OCP NIC 3.0 Design Specification

Version 0.63

Author: OCP Server Workgroup, OCP NIC subgroup

Commented [NT1]: Mechanical drawings will be updated 1/19/2018

Figure 33: Port and LED Ordering – Example Small Card Link/Activity and Speed LED Placement

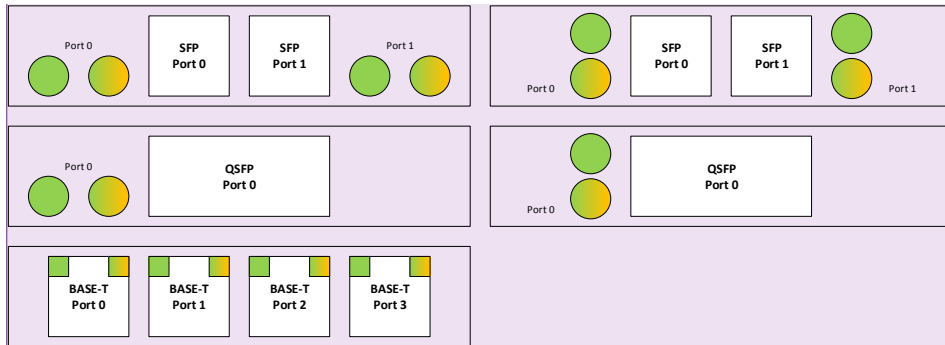
Commented [JN4]: Suggest to add illustration of PCB in order to show this is "up side up"

Figure 54: Small Size Primary Connector Gold Finger Dimensions – x16 – Bottom Side (“A” Pins)

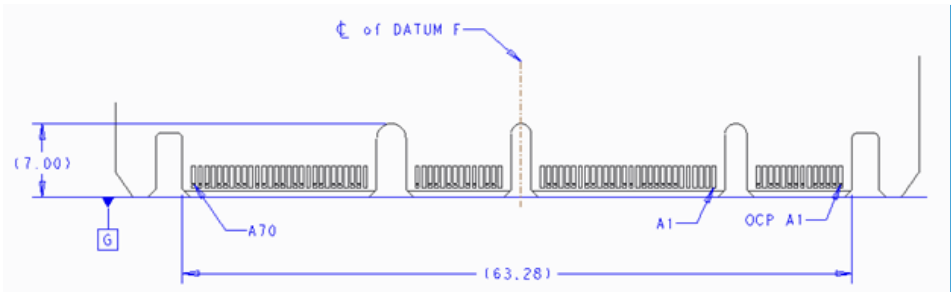
Commented [TN12]: SFF-TA-1002 draft 1.1 doesn't have a diagram that shows the "A-side" pins facing up. Delete?

Figure 55: Large Size Card Gold Finger Dimensions – x32 – Top Side (“B” Pins)

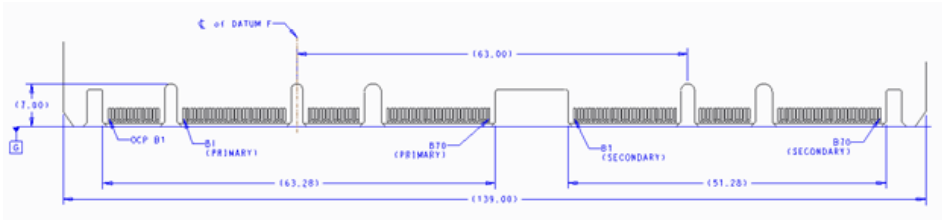
Commented [TN13]: Need new mechanical drawing for the Large Card – B side.

Figure 56: Large Size Card Gold Finger Dimensions – x32 – Bottom Side (“A” Pins)

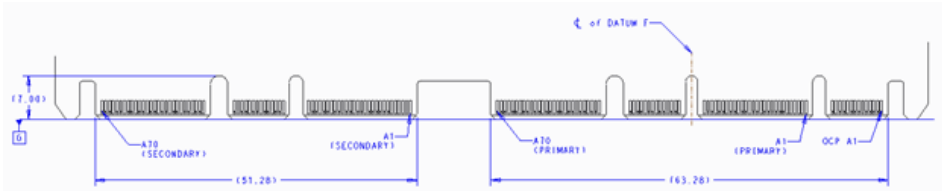
Commented [TN14]: Need new mechanical drawing for the Large Card – A side.

Perhaps we can delete the A side. The pins are stacked at the same spots on the A and B sides anyway.

Figure 58: 140-pin Base Board Secondary Connector – Right Angle

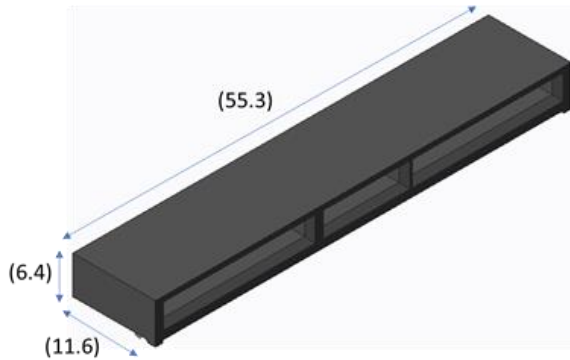
Commented [TN18]: Need new ¾ view drawing.

Figure 60: 168-pin Base Board Primary Connector – Straddle Mount

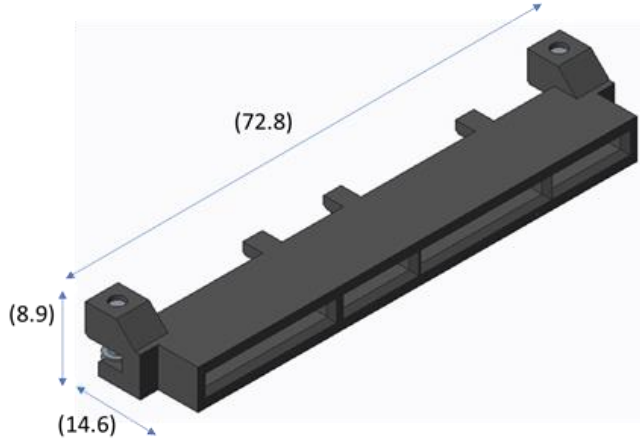
Commented [TN19]: This 4C+ drawing needs to be updated.

Figure 61: 140-pin Base Board Secondary Connector – Straddle Mount

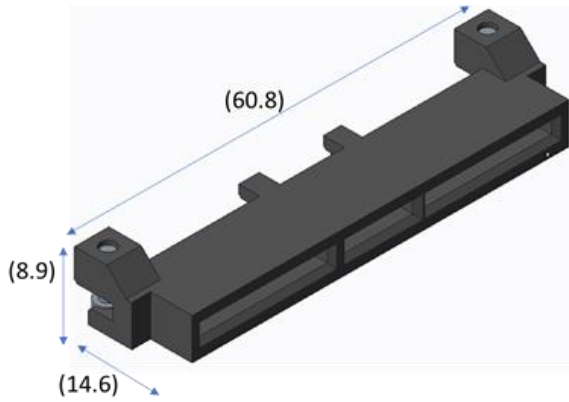
Commented [TN20]: Does this 4C drawing need to be updated?

Figure 65: Primary and Secondary Connector Locations for Large Card Support with Right Angle Connectors

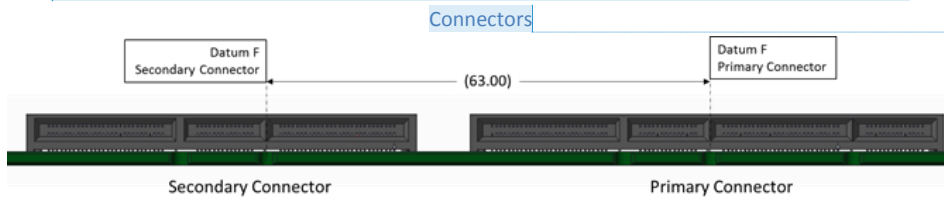
Commented [TN21]: Double check this drawing with the MEs.

Figure 66: Primary and Secondary Connector Locations for Large Card Support with Straddle Mount Connectors

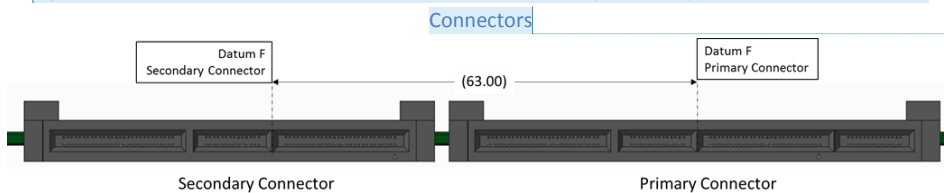
Commented [TN22]: Double check this drawing with the MEs.
